## **Product Change Notice (PCN)**

PCN Number: PCN-0454905R-01

Product(s) Affected: PJ-079BH

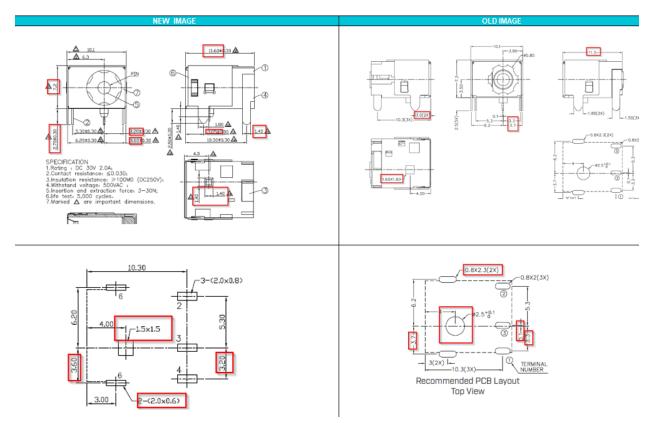
Description of Change: Minor Housing and footprint differences. Material Change on the

housing and terminals. See image Below

Housing and Terminal Material Changes:

Center Pin: Copper to Brass Terminal 2: Copper Alloy to Brass Plastic: PA6T or Equivalent to PA9T
